ASSESSMENT REPORT

Section 75W Modification – Gas Pipeline Jacks Gully Alternate Waste Technology Facility (05_0098 Mod 3)

Figure 3: MRRP - Proposed Gas Pipeline to AWT Facility

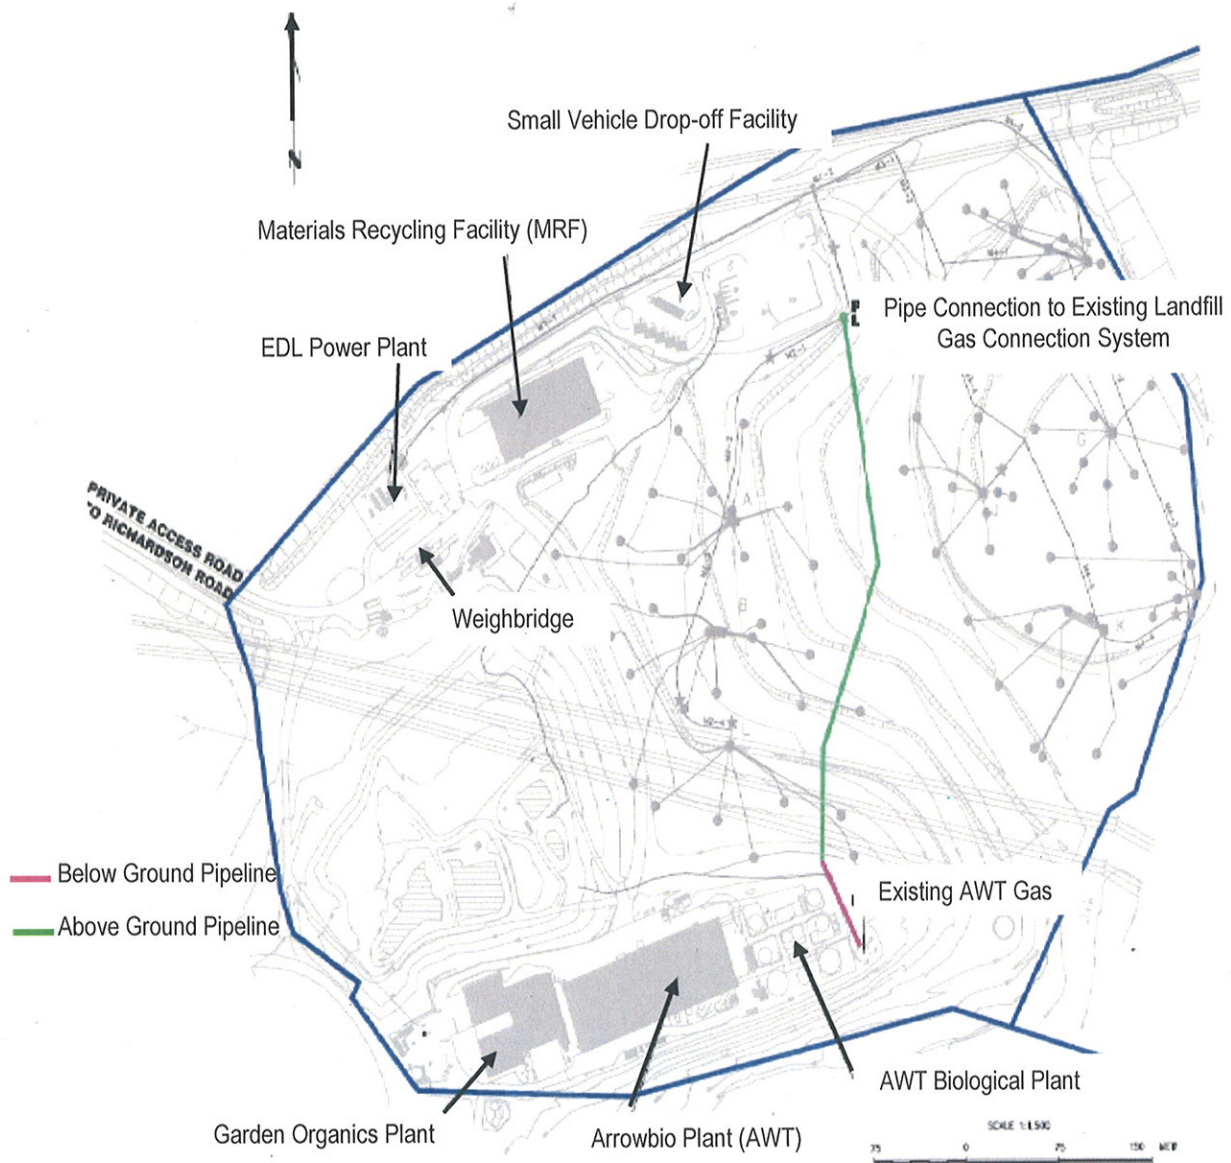
- the 670 metre long pipeline has largely been constructed underground with 100 mm diameter stainless steel and as such corrosion is not a concern. However, third party damage could still occur, causing leaks from the line;

- the pipeline would operate at a very low pressure (approximately 3-5 Kpa) and would not cause any accumulation of methane gas as the gas is lighter than air and would dissipate to the atmosphere without forming a flammable cloud; and

- the HAZOP study identified a number of issues due to the specific requirements of the AWT plant. Against each of these issues, measures for WSN's actioning were identified. Many of these were related to the requirement for procedures, signage or regular inspection. However, a number were related to the requirement for updated hardware equipment or clarification of system design details.

The Department considers that given the nature of the works and the isolation of the pipeline from sensitive receptors, the hazards and risks associated with the pipeline and its equipment such as gas leaks that could cause fire, are low and acceptable subject to:

- the implementation of the proposed safeguards and actions listed in Appendix A of the HAZOP study report dated August 2009; and
- the preparation of a Commissioning Procedure and a Safety and Operating Plan (SAOP) for the pipeline.
